Ikes at Cambria
8001 28th Avenue South
PL201900209

CAMBRIA RESTAURANT

TITLE SHEET

2
A1.3 RETAINING WALL DETAIL
SCALE: 1/2" = 1'-0"

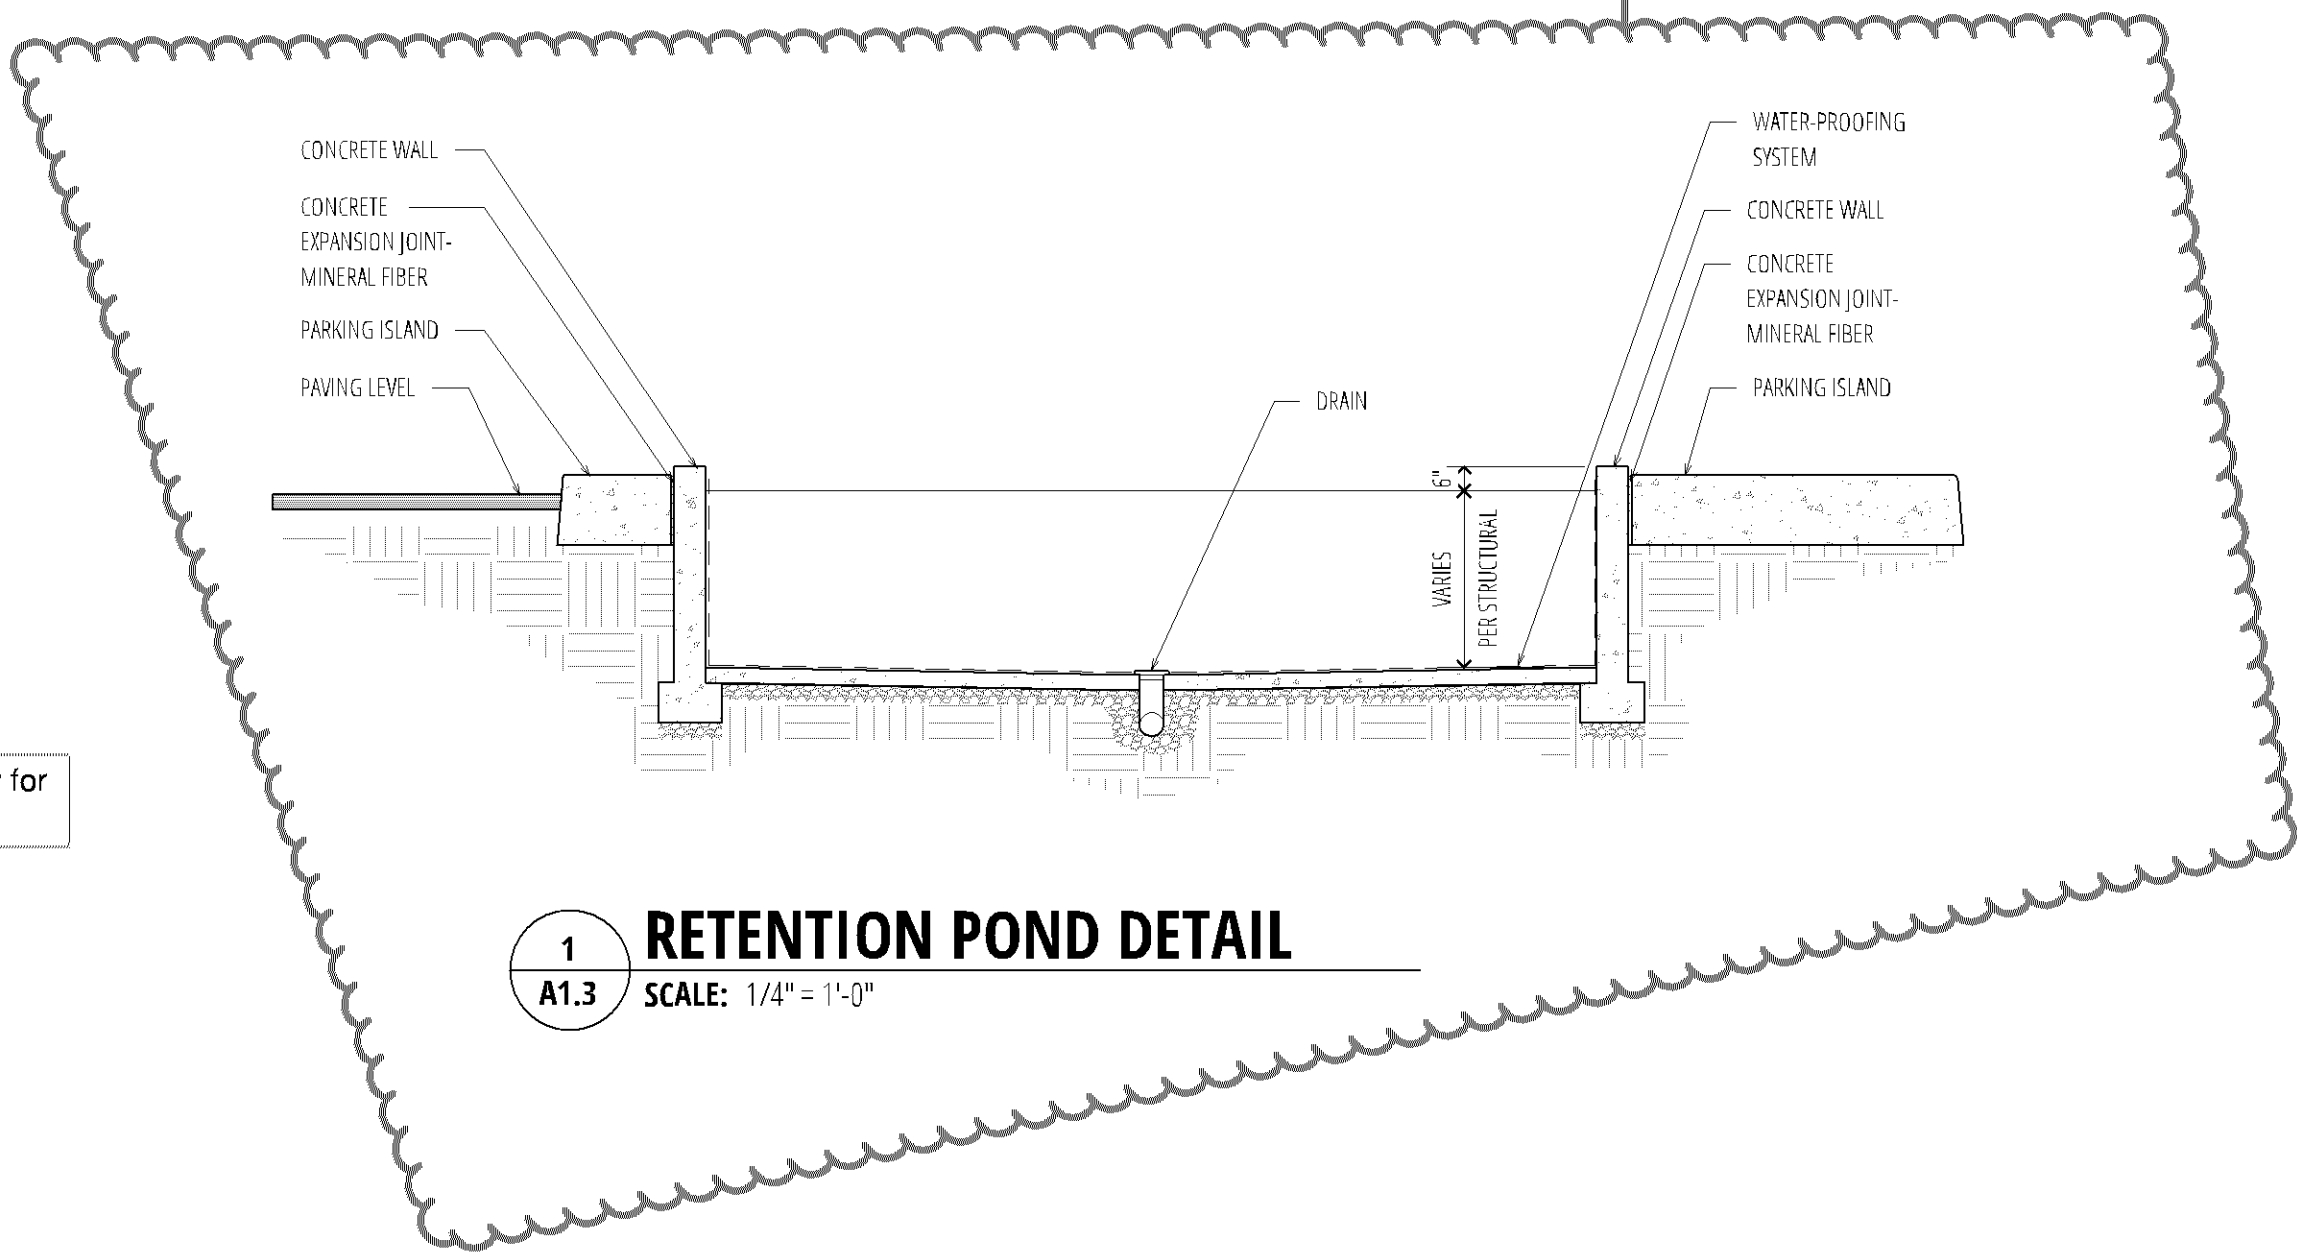
Retaining wall not shown on site plan. Is this for the stormwater pond? If so it needs to show proposed slopes and accurate adjacent materials

This detail does not match grading plan.

SHEET NO:
A1.4
LANDSCAPE PLAN

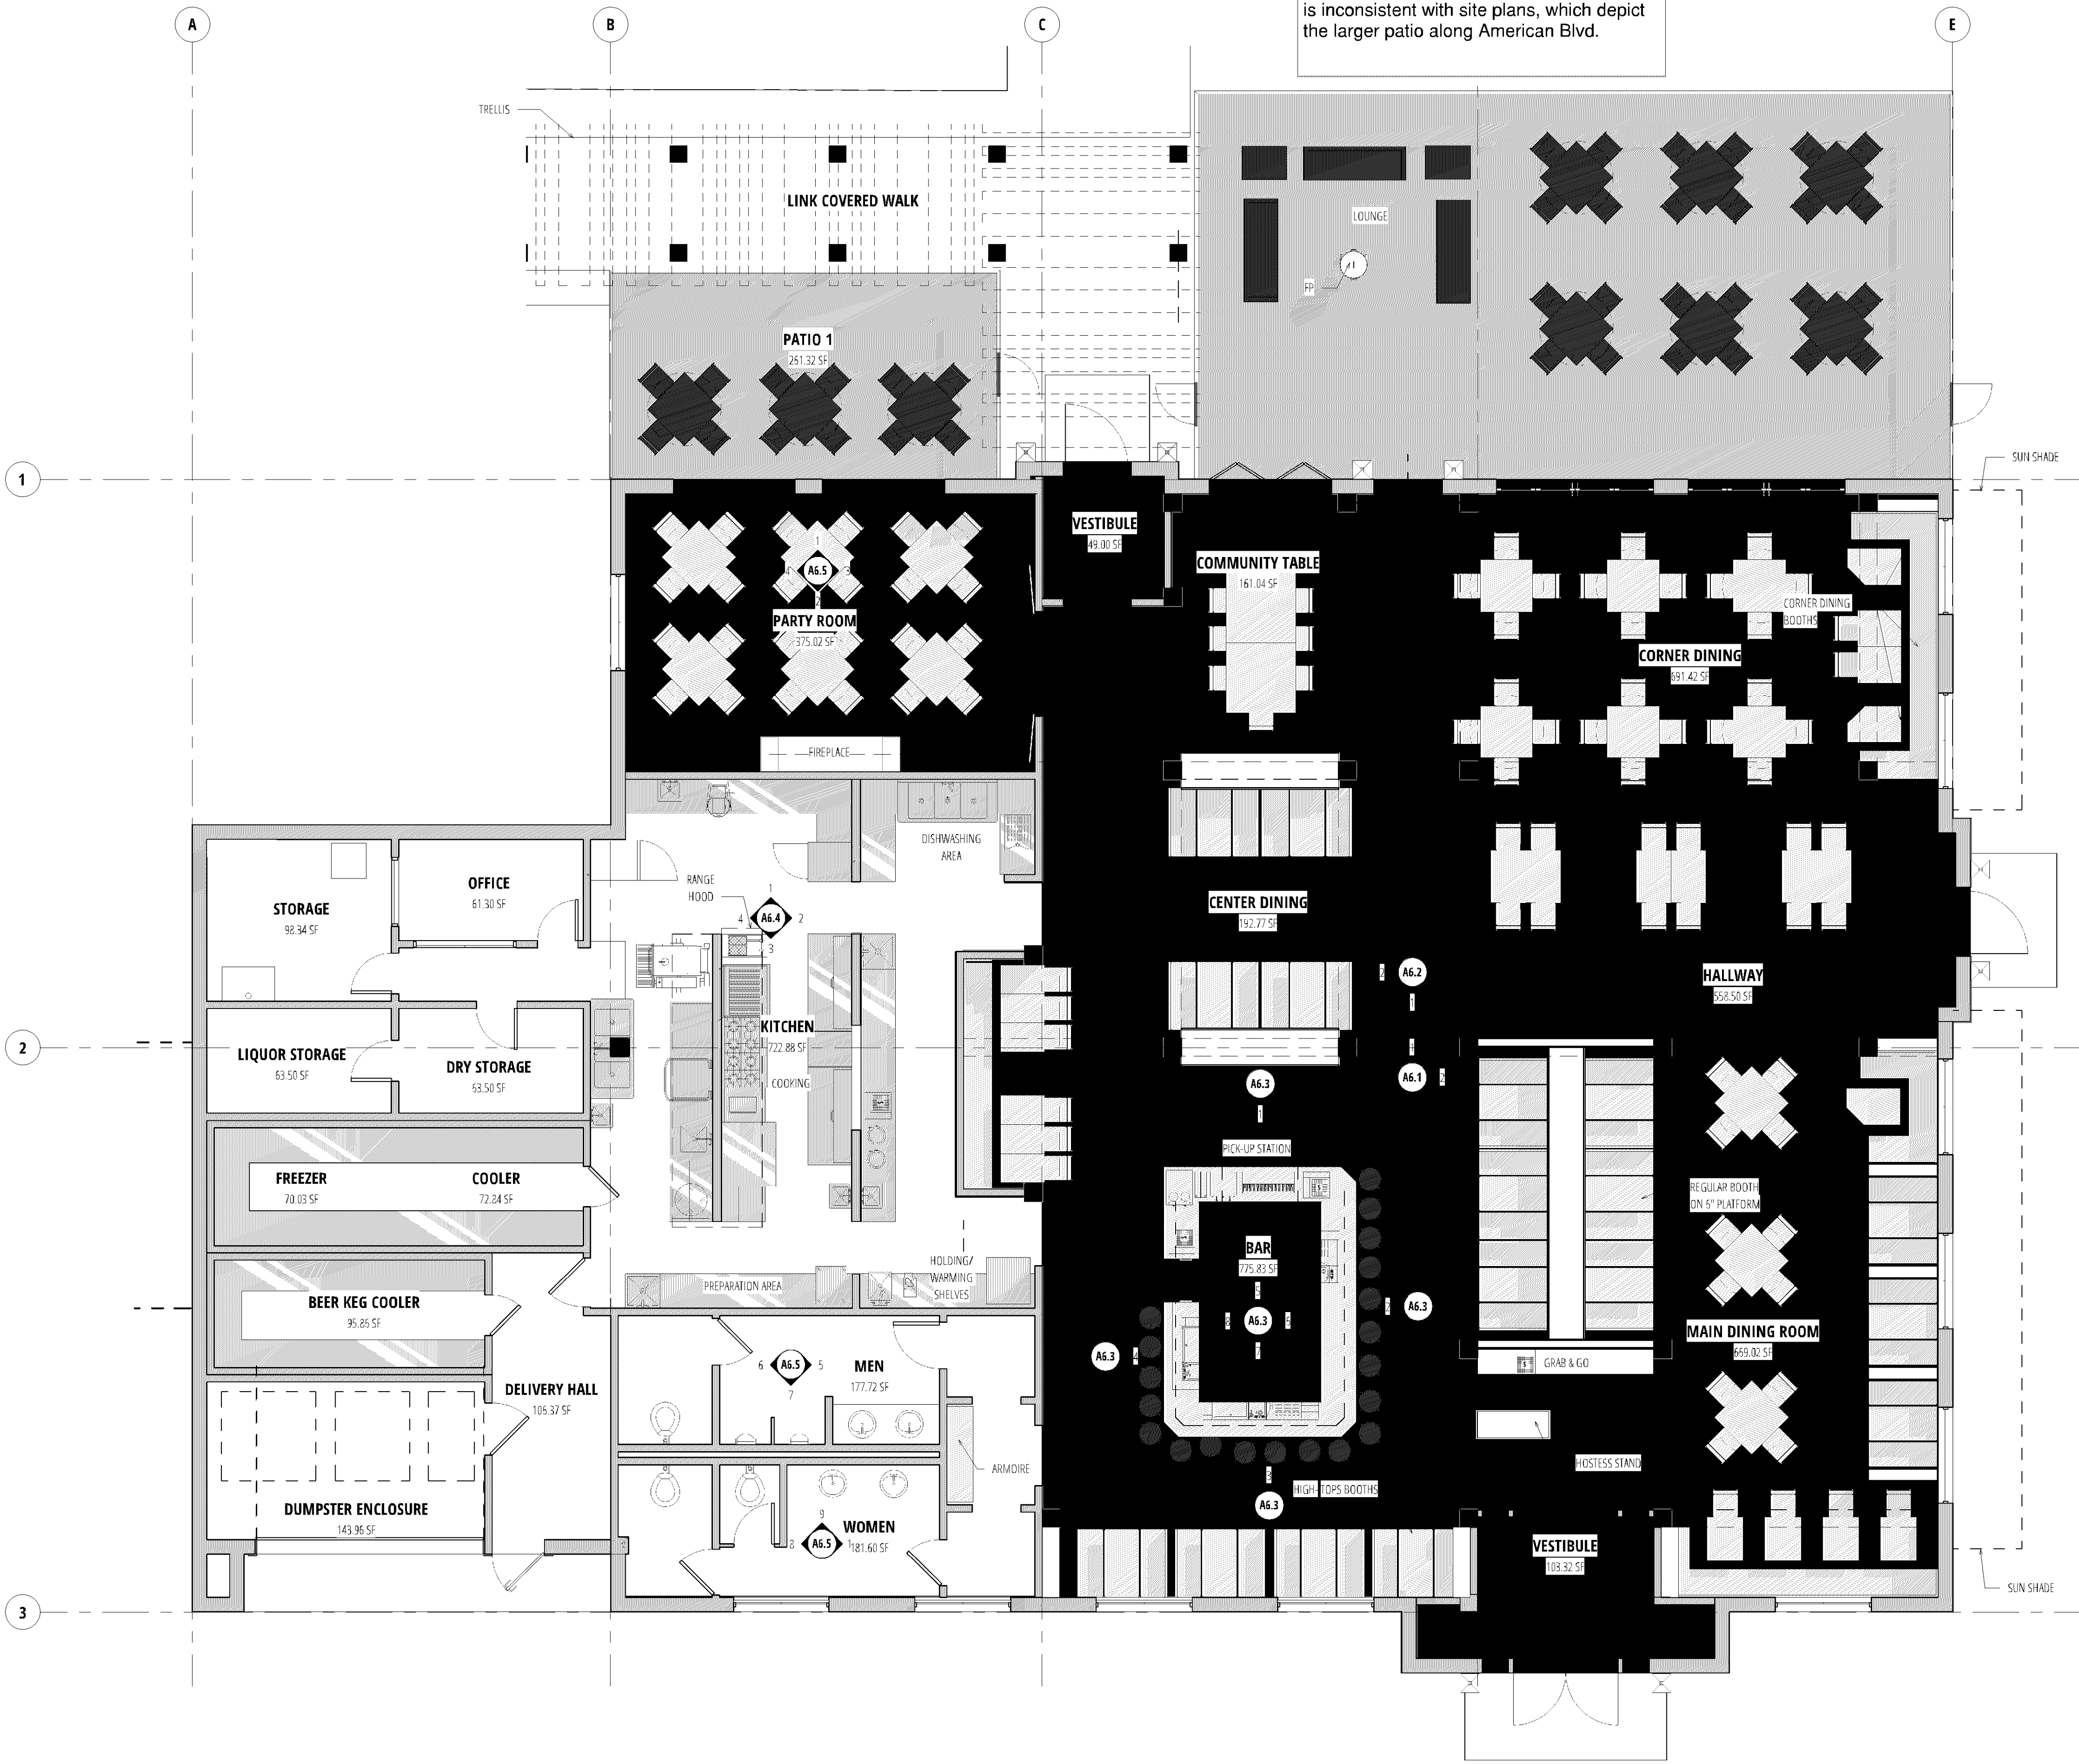
The American Blvd. frontage does not meet the minimum 30 percent building enclosure requirement.
